**AMA2 - Replacing Seat Occupancy Detection System for Passenger Seat (USA/Canada)  
(Recall Campaign)**

Revision: This bulletin replaces bulletin Group 6 50/21 AMA2, dated November 4, 2021.

Model Line: **Macan**

Concerns: **Seat occupancy detection system for passenger seat**

*Contents of occupant classification system repair kit*

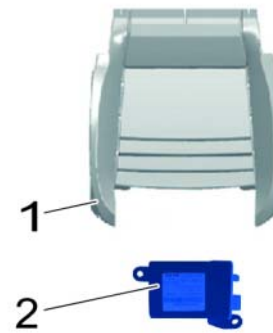
When replacing the occupant classification components, all coordinated components (padding, sensor mat and control unit) in the repair kit must be replaced.

Due to worldwide semiconductor bottlenecks at individual suppliers, we were **unfortunately unable to include** the corresponding **occupant classification control units** in the repair kit as part of this campaign.

To avoid delay in the implementation of this measure, the **occupant classification control unit installed in the vehicle is reused** in this particular case.

- 1 – Padding with affixed sensor mat - **replace**
- 2 – Occupant classification control unit - **reuse**

- The **sensor mat** for the occupant classification system must **not be removed** from the foam part.
- **Mixed installation**, e.g. "old" padding and "new" sensor mat, is **not permitted**.
- The **existing control unit** for occupant classification must not be removed and must be **reprogrammed** with the provided programming box.
- The one-time procurement of the required programming box can be found in the section "Required tools".
- The **direct programming of the control unit** occupant classification with the currently valid software is **only approved and released within the scope of this campaign**.
- **After carrying out this campaign**, in the event of a further repair case, the **usual repair concept with complete replacement of all components** (including control units) for occupant classification **must be used**.

Overview of padding

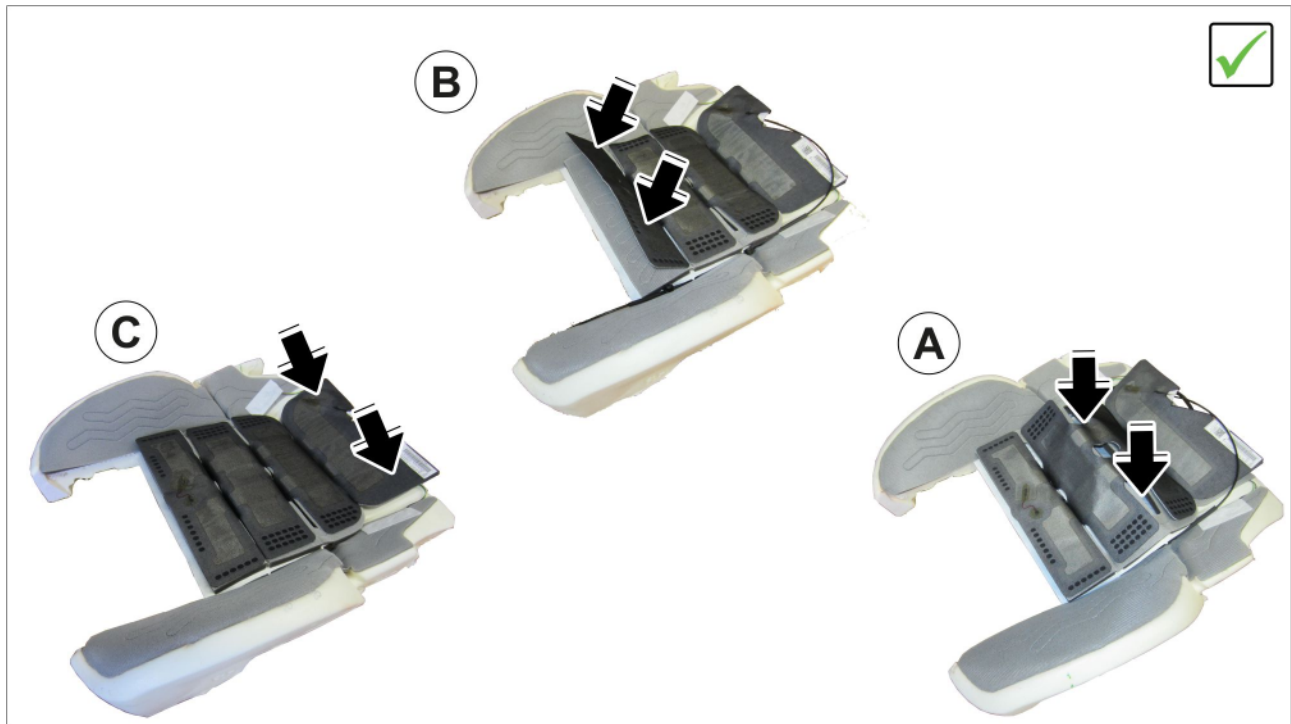
Between delivery of the padding to its installation in the front seat, the glued sensor mat can partially detach from the foam part over longer periods of time. This does not constitute a material defect and will have no influence on the quality of the sensor mat.

If the sensor mat has come loose as shown in the picture, then the sensor mat must be pressed back in place before installation as shown in pictures A, B, C.  
 Complete adhesive strength is only achieved after attaching or clamping the seat cover.

*Troubleshooting process AMA2*

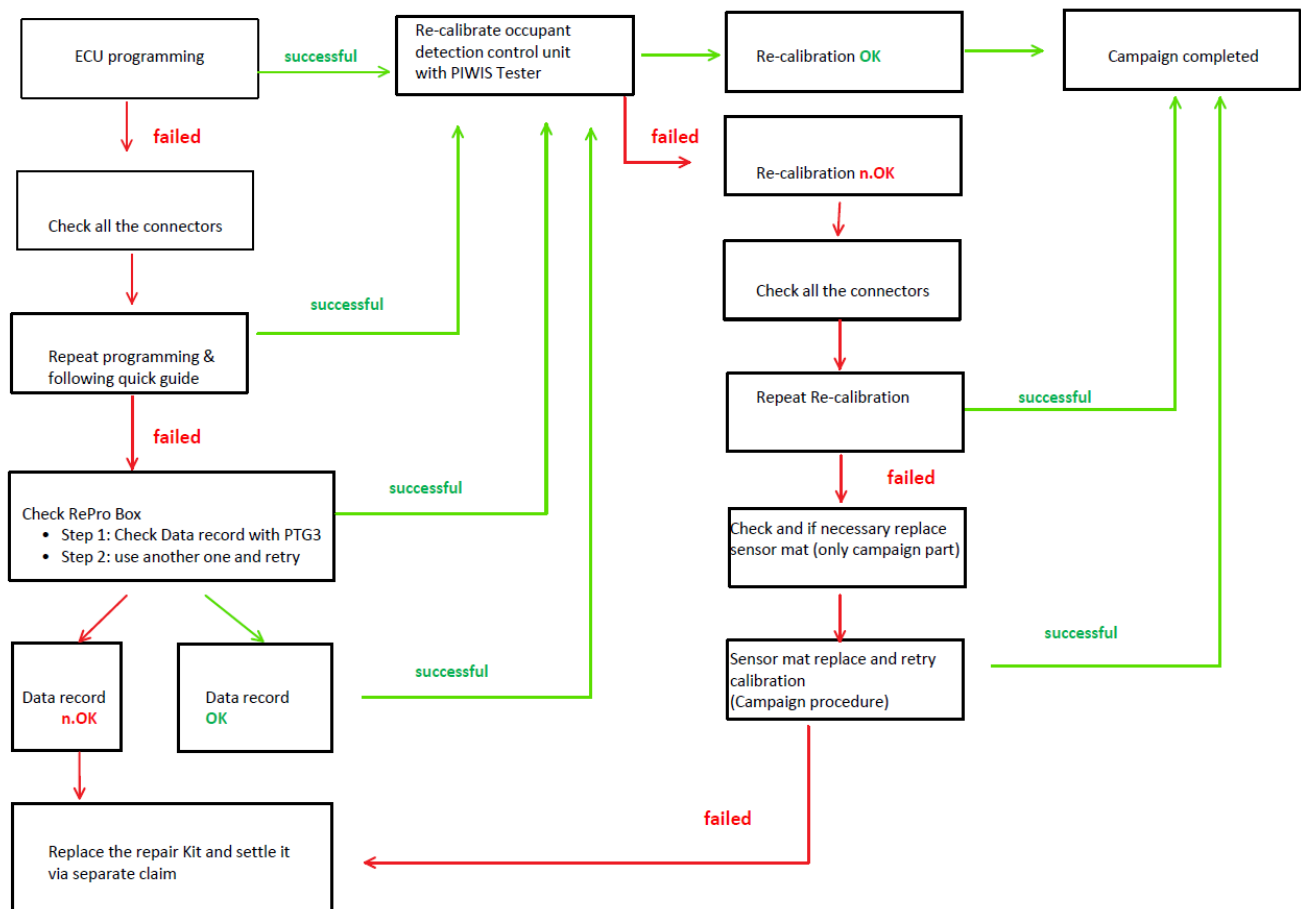
If individual programming steps or subsequent work could not be carried out correctly, see Workshop Manual for the basic procedure for control unit programming using the PIWIS Tester Workshop Manual '9X00IN Basic instructions and procedure for control unit programming using the PIWIS Tester - section on "Fault finding". : You will also find further information and instructions specifically for the programming and calibration procedures in the fault-tree diagram below:
